SCOPING OPINION:

Proposed Humberhead Solar

Case Reference: EN0110032

06 July 2026

Figure 1: NGET Assets in proposed development area

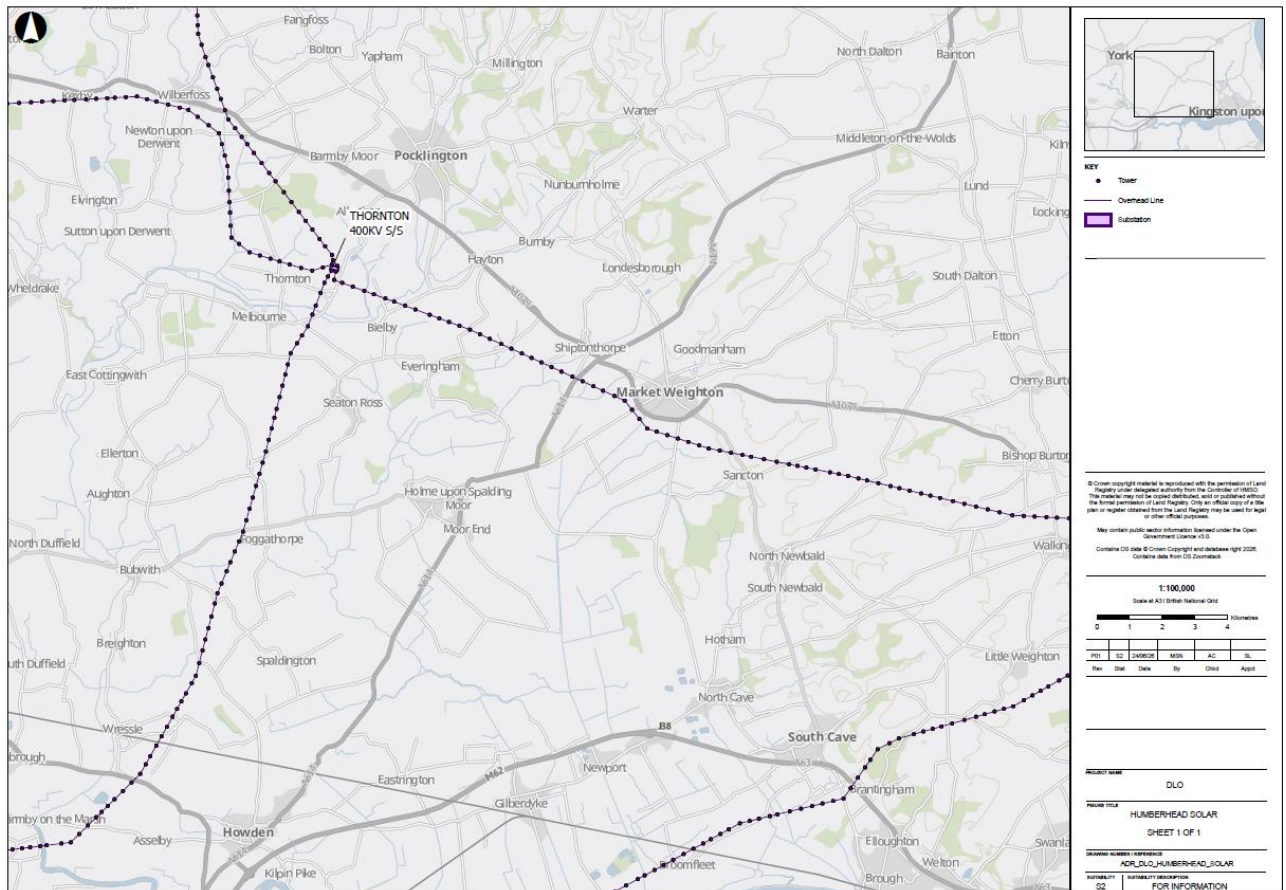
We enclose a plan showing the location of NGET's apparatus in the scoping area.

Diagram not to scale

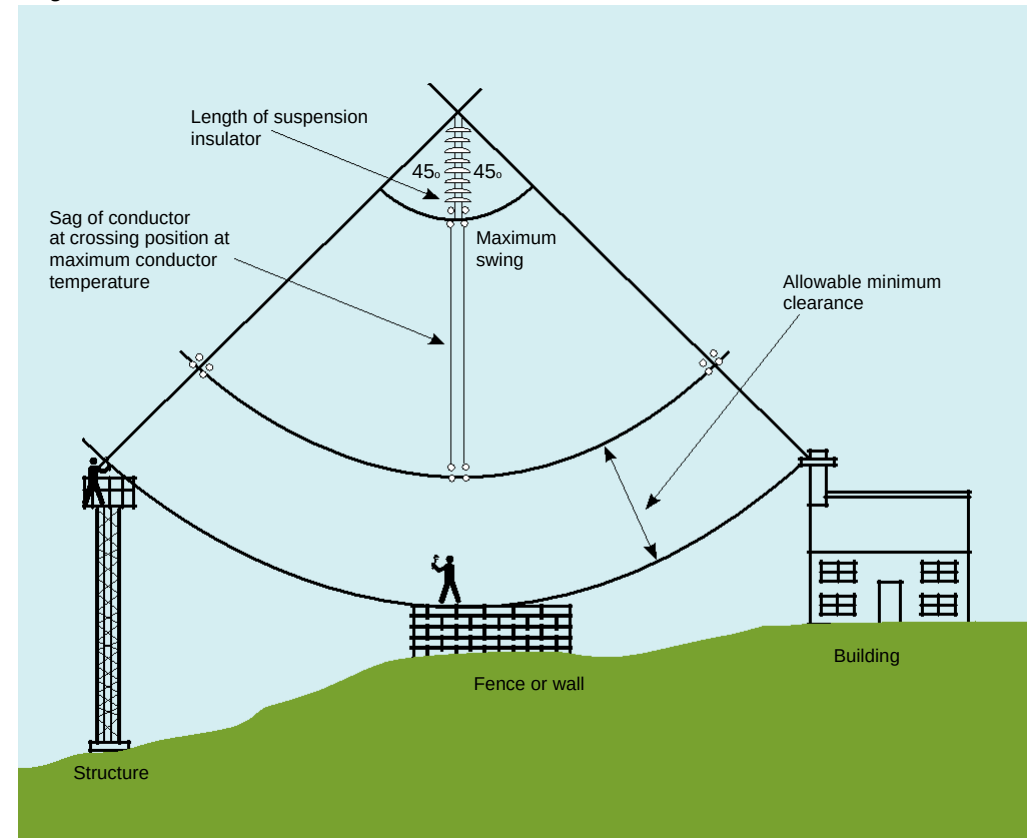
The required clearance from the point where a person can stand to the conductors is 5.3m. To be clear, this means there should be at least 5.3m from where someone could stand on any structure (i.e. mobile and construction equipment) to the conductors. Available clearances will be assessed by National Grid on an individual basis.

There should be at least 5.3m between the conductors and any structure someone could stand on

Diagram not to scale

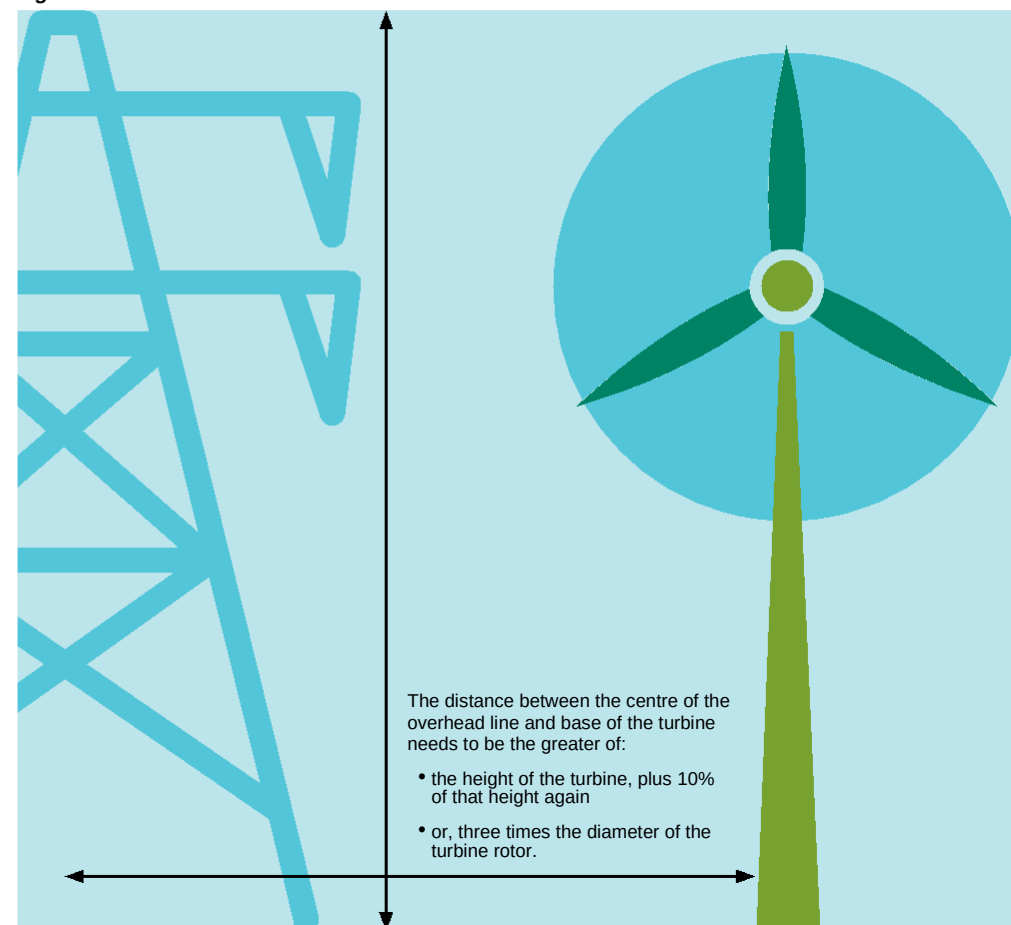
Turbines should be far enough away to avoid the possibility of toppling onto the overhead line

Diagram not to scale

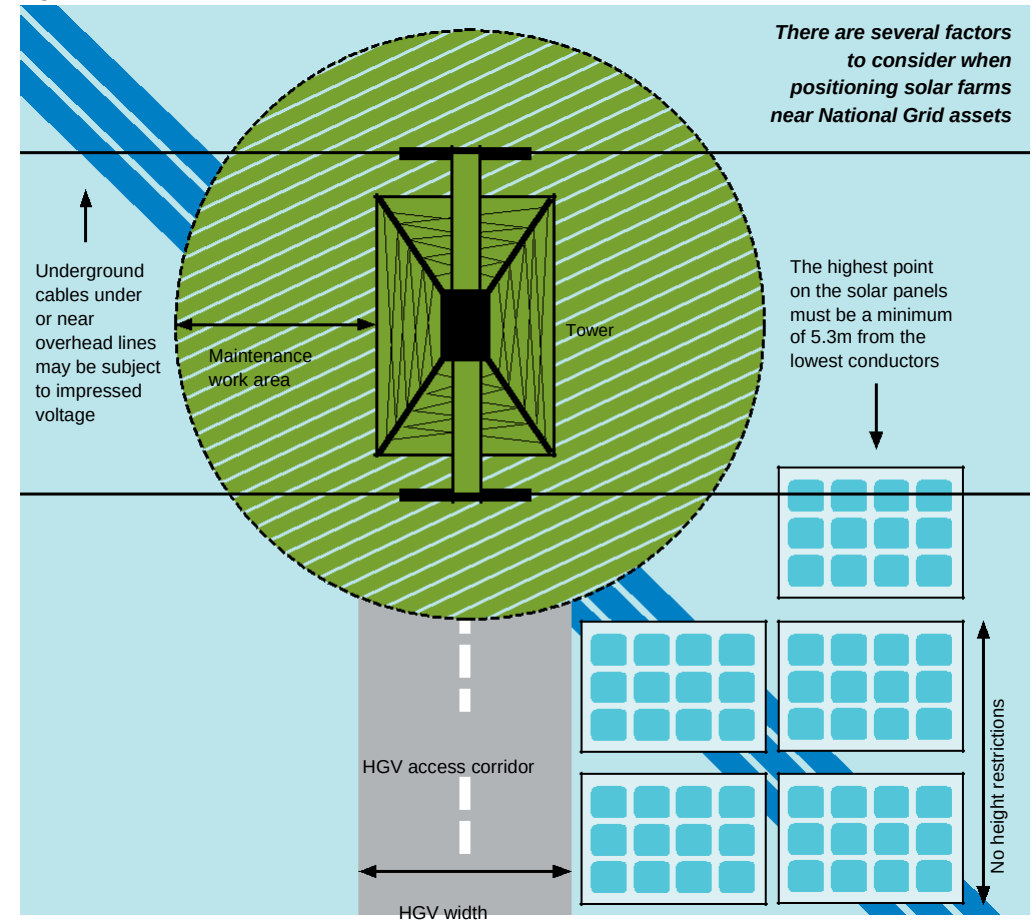
Any metallic fencing that is located under an overhead line will pick up an electrical charge. For this reason, it will need to be adequately earthed to minimise microshocks to the public.

For normal, routine maintenance and in an emergency National Grid requires unrestricted access to its assets. So if a tower is enclosed in a solar farm compound, we will need full access for our vehicles,

Including access through any compound gates. During maintenance – and especially re-conductoring – National Grid would need enough space near our towers for winches and cable drums. If enough space is not available, we would require solar panels to be temporarily removed.
